NPP Fennovoima

Expert Statement to the EIA Report

Ordered by the Federal Ministry for Agriculture, Forestry, Environment
and Water Management, Project Management Department V/6
"Nuclear Coordination"

REPORT
REP-0196

Figure 1: Example of deposition of Cs-137 over Europe resulting from a hypothetical severe accident in the new NPP at Kampuslandet (near Loviisa), assuming a release of 25,500 TBq in the hour after 1995-07-28 06:00. Output grid size is 1°.

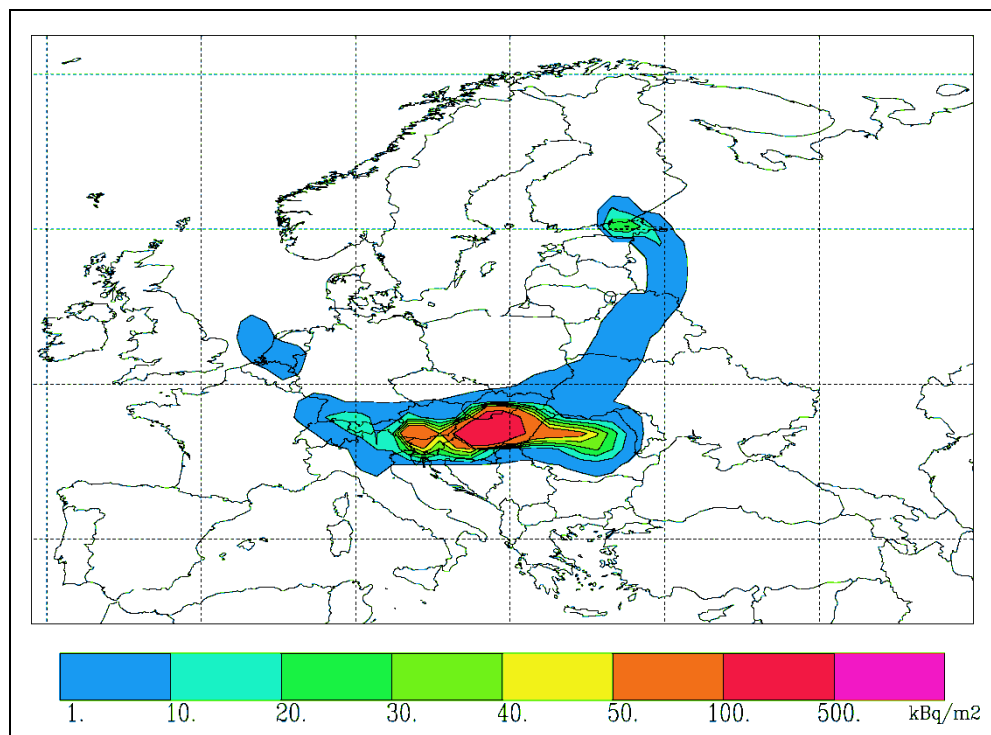
The figure shows a worst-case scenario for Austria and Hungary, where the south of Austria would receive a deposition above 50 kBq Cs-137/m² on a larger area, and almost all of Hungary would be contaminated higher than 100 kBq/m² Cs-137. During spring and summer food bans and restriction in stock farming would be necessary if such a situation were to become reality.

If a deposition of 50 kBq/m² is exceeded in Austria as it is indicated in figure 1, during spring and summer food bans and restriction in livestock farming would be necessary if such a situation were to become reality. 50 kBq/m² correspond to an effective dose of 2.5 mSv for the first year, which implies the Austrian warning scale level 2 requiring protection measures for children, expectant and breast-feeding mothers (RAHMENEMPFEHLUNGEN 1992). The new order for intervention in radiological emergencies (INTV 2007) recommends sheltering for risk groups if an effective dose of 1 mSv in seven days could be exceeded. Because the largest part of the dose will be received in the first week after an accident it cannot be excluded that the intervention limit for seven days could also be exceeded.

Figure 3: Example of deposition of Cs-137 over Europe resulting from a hypothetical severe accident in the new NPP near Loviisa, assuming a release of 25,500 TBq in the hour after 1995-07-28 03:00. Output grid size is 1°.

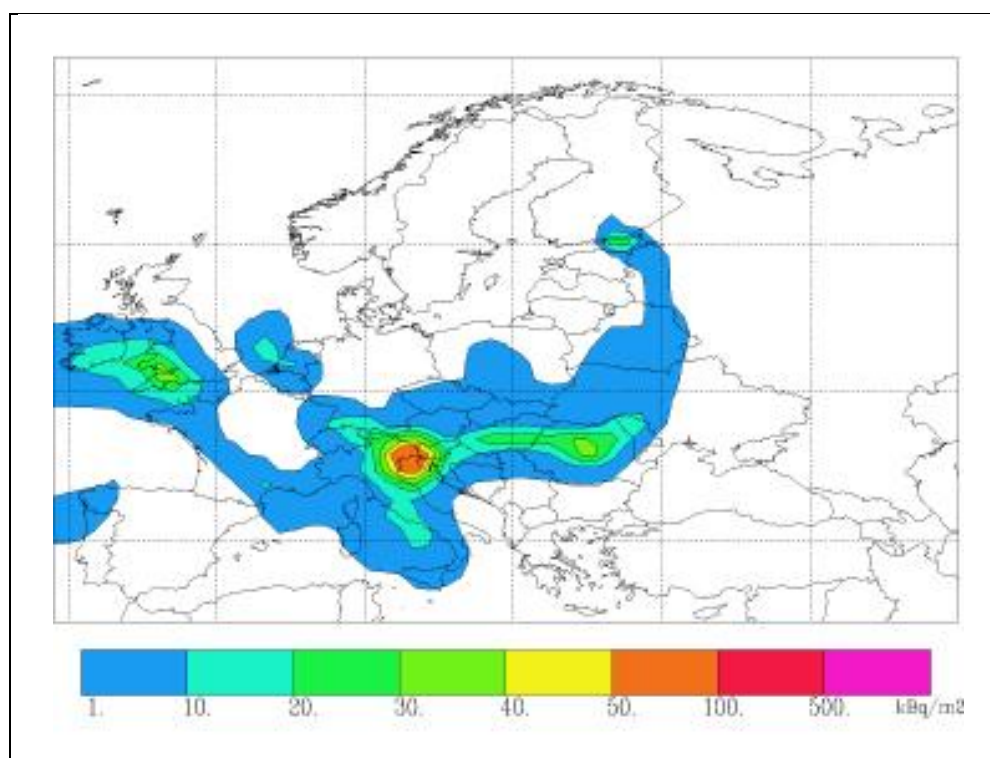
For a release from Loviisa on 28 July 1995 around 03 UTC (figure 3), we find a contamination band extending southeastward from the site through Russia, Belarus and Ukraine into Romania. In Romania, the intensity of the deposition increases from below 10 to around 30 kBq/m², an indication of transport in dry weather first and then coming under precipitation causing wet deposition.

This change in the weather is also marked by the change in the transport direction, first southward with northerly winds, then westward with easterly winds. The contaminated air arrives then over northeastern Italy where intensified precipitation would cause contamination of up to 66 kBq/m². This contamination area would include southern and western Austria with values between 20 and 50 kBq/m². Then

Figure 4: Example of deposition of Cs-137 over Europe resulting from a hypothetical severe accident in the new NPP near Loviisa, assuming a release of 25,500 TBq in the hour after 1995-11-06 17:32. Output grid size is 1°.

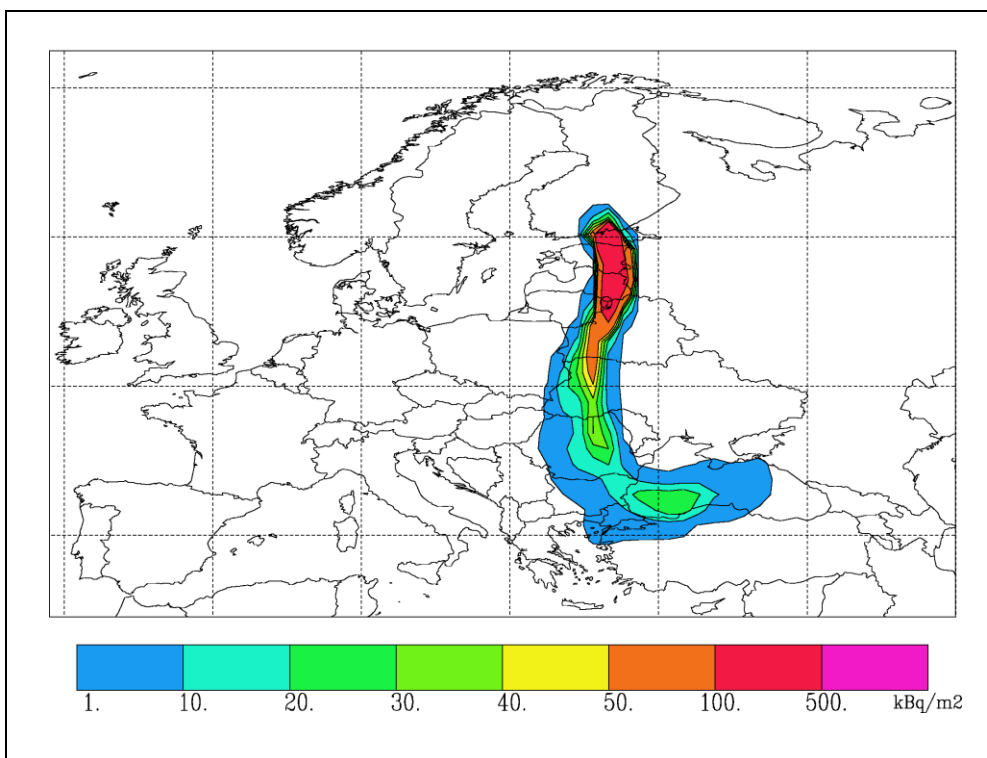
For the site near Loviisa we found two consecutive hypothetical accident dates in November. The first one is associated with a release on 2 November 1995 at 16 UTC and it would lead to severe contamination around the site, then air being transported over the Baltic Sea and through Germany, finally reaching the border region of Germany, Austria and Switzerland. Austria, in the city of Bregenz, would just receive 10 kBq/m². However, fewer rain before could easily increase this value. The next release time studied, 6 November 1995 at 17:32 UTC, leads to a transport of the contaminated air straight to the south, impacting the Baltic countries and Romania (figure 4). One can imagine that a release at an intermediate time might have hit Austria directly.

Figure 5: Example of deposition of Cs-137 over Europe resulting from a hypothetical severe accident in the new NPP at Kampuslandet (near Loviisa), assuming a release of 25,500 TBq in the hour after 1995-07-28 03:00. Output grid size is 1°.

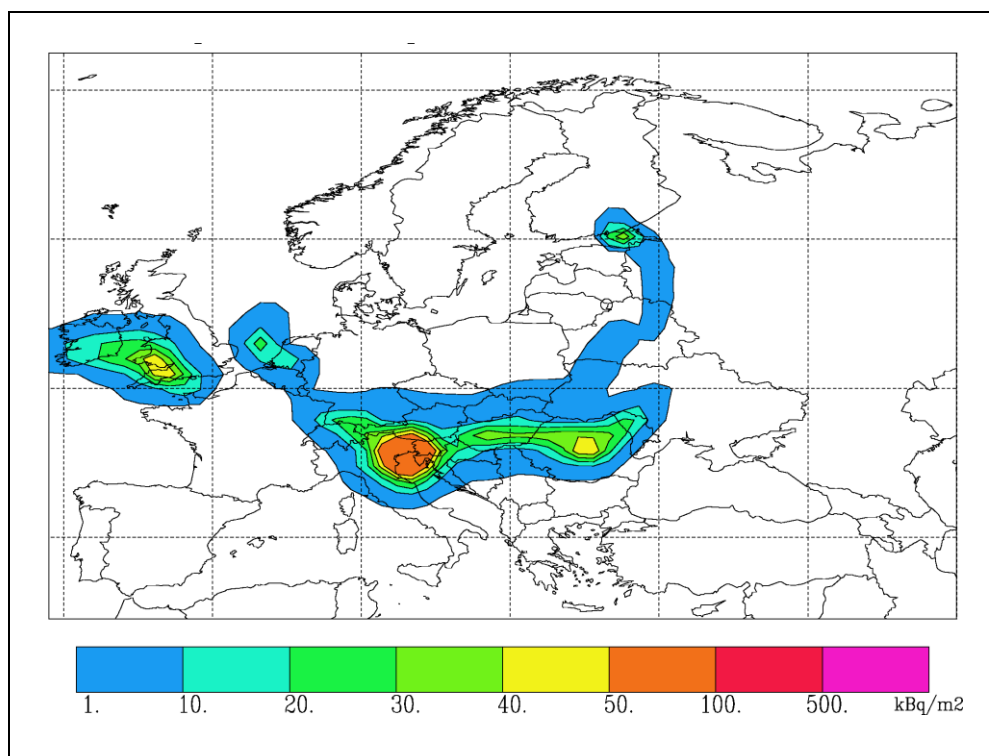
For Kampuslandet and the same release time already studied with Loviisa, this approach yields very similar results, as expected (figure 5). According to the lower release height, the contamination values are a bit higher.

Figure 6: Example of deposition of Cs-137 over Europe resulting from a hypothetical severe accident in the new NPP at Kampuslandet (near Loviisa), assuming a release of 25,500 TBq in the hour after 1995-07-28 06:00. Output grid size is 1°.

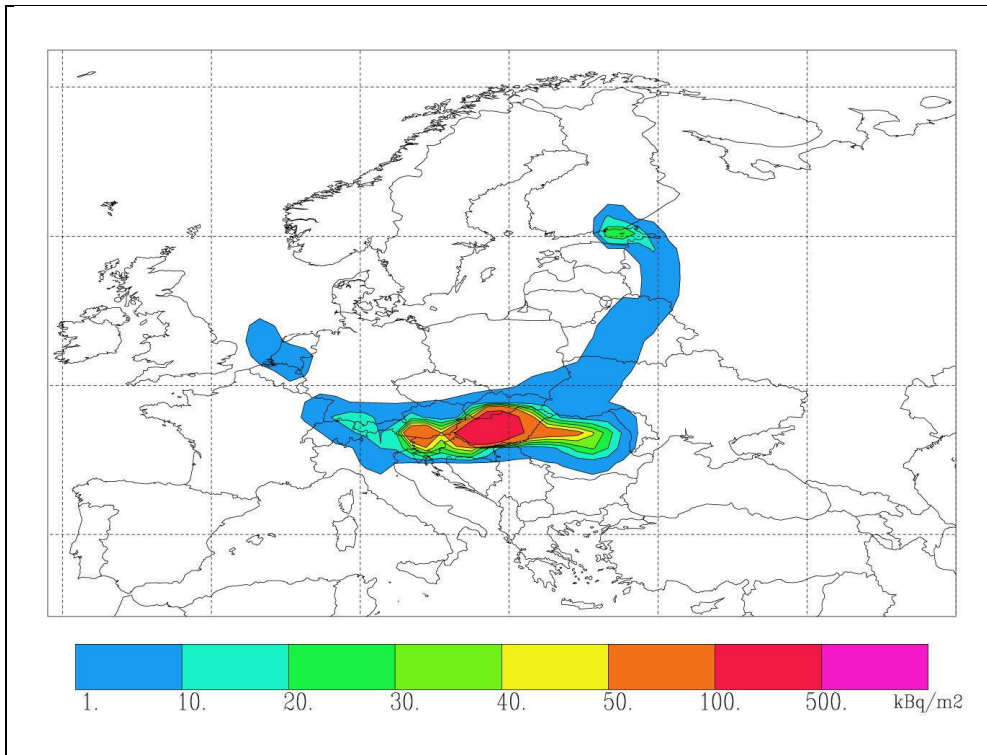
If the release at Kampuslandet is assumed 3 hours later (figure 6), the south of Austria would receive above 50 kBq/m² on a larger area, and almost all of Hungary would be contaminated above 100 kBq/m². With a slightly different weather pattern, such contamination could also hit the eastern part of Austria. Also with releases on 30 July contamination of large parts of Austria is simulated. In the case of a release at 09 UTC, the centre of contamination would be in Czech Republic and touch the north of Austria.

If a deposition of 50 kBq/m² is exceeded in Austria as it is indicated in figure 6, during spring and summer food bans and restriction in livestock farming would be necessary if such a situation were to become reality. 50 kBq/m² correspond to an effective dose of 2.5 mSv for the first year, which implies the Austrian warning scale level 2 requiring protection measures for children, expectant and breast-feeding mothers (RAHMENEMPFEHLUNGEN 1992). The new order for intervention in radiological emergencies (INTV 2007) recommends sheltering for risk groups if an effective

dose of 1 mSv in seven days could be exceeded. Because the largest part of the dose will be received in the first week after an accident it cannot be excluded that the intervention limit for seven days could also be exceeded.

Figure 7: Example of deposition of Cs-137 over Europe resulting from a hypothetical severe accident in the new NPP at Hanhikivi, assuming a release of 25,500 TBq in the hour after 1995-07-30 03:00. Output grid size is 1°.

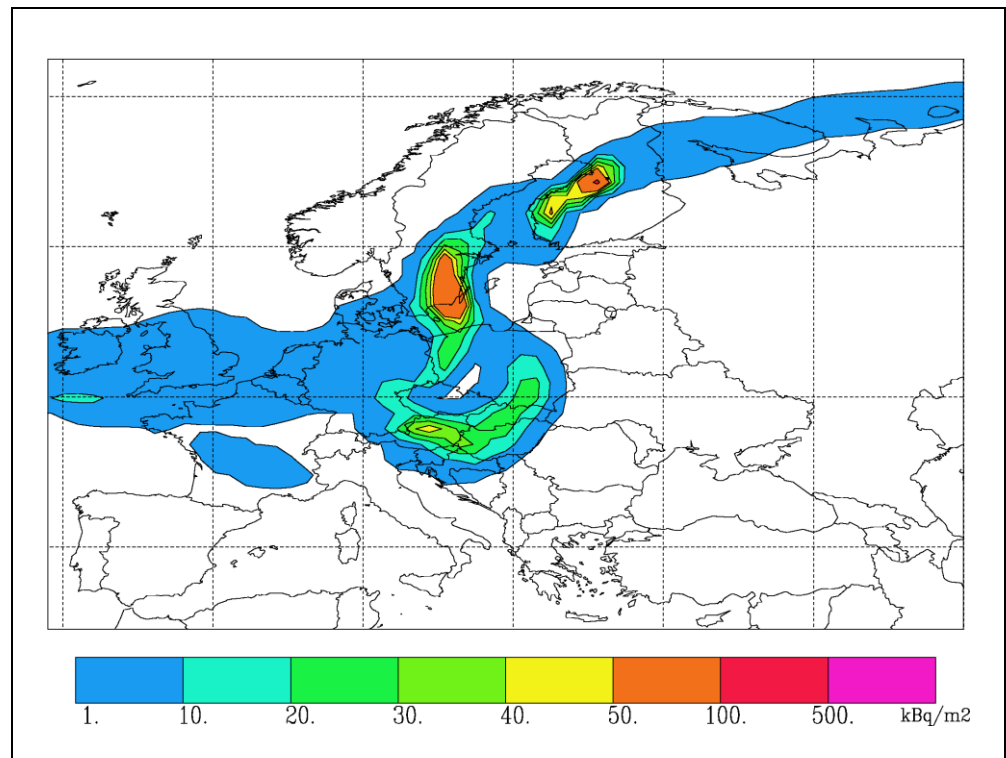
At the more northern site of Hanhikivi, a release on 30 July 1995 at 03 UTC was found to have the most negative consequences for Austria (figure 7). The central part of the country would be contaminated with more than 40 kBq/m² and the whole area to the east of the line Salzburg – Klagenfurt would be contaminated with more than 10 kBq/m².

Figure 8: Example of deposition of Cs-137 over Europe resulting from a hypothetical severe accident in the new NPP at Karsikkoniemi, assuming a release of 25,500 TBq in the hour after 1995-07-29 15:00. Output grid size is 1°.

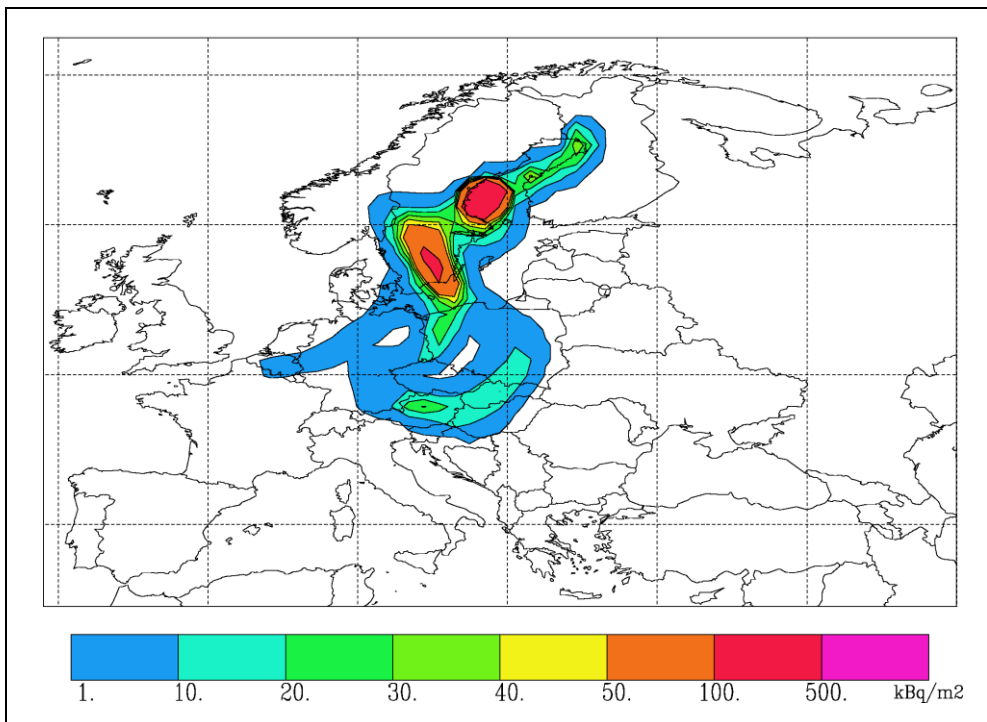
Finally, for the northernmost site Karsikkoniemi two dates with similar impact on Austria were found in the investigation period, with releases on the 28th at 21 UTC and on the 29th at 15 UTC, July 1995. Both lead to contamination between 10 and 30 kBq/m² in the eastern part of Austria, the first one more in the south, the second one more in the north (figure 8).
